**Economic Commission for Europe****Inland Transport Committee****World Forum for Harmonization of Vehicle Regulations****Working Party on General Safety Provisions****114th session**

**UN Regulation No. 73 (Lateral protection devices)****Proposal for the 02 series of amendments to UN Regulation No. 73  
(Lateral Protection Devices)****Submitted by the expert from France\***

Figure 1

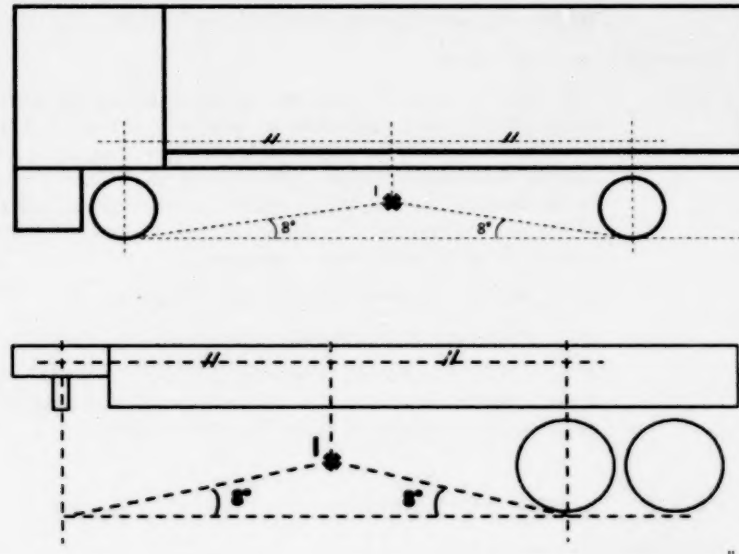
*Paragraph 12.8., amend to read:*

- "12.8. The lower edge of LPD shall **be defined as follows:**
  - (a) **If  $I \leq 350$  mm then the ground clearance can be 350 mm maximum;**
  - (b) **If  $350\text{mm} < I \leq 450\text{mm}$  then the ground clearance is I;**
  - (c) **If  $450\text{mm} < I$  then the ground clearance is 450 mm maximum;****with intersection point I defined as mentioned in Figure 1.**

Figure 2

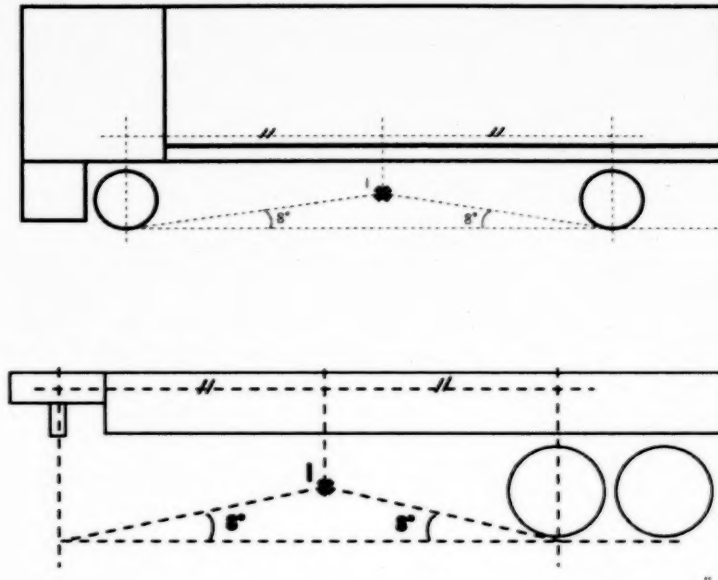
*Paragraph 15.6., amend to read:*

"15.6. The lower edge of LPD shall be defined as follows:

- (a) If  $I \leq 350$  mm then the ground clearance can be 350 mm maximum;
  - (b) If  $350 \text{ mm} < I \leq 450$  mm then the ground clearance is I;
  - (c) If  $450 \text{ mm} < I$  then the ground clearance is 450 mm maximum;
- with intersection point I defined as mentioned in Figure 2.
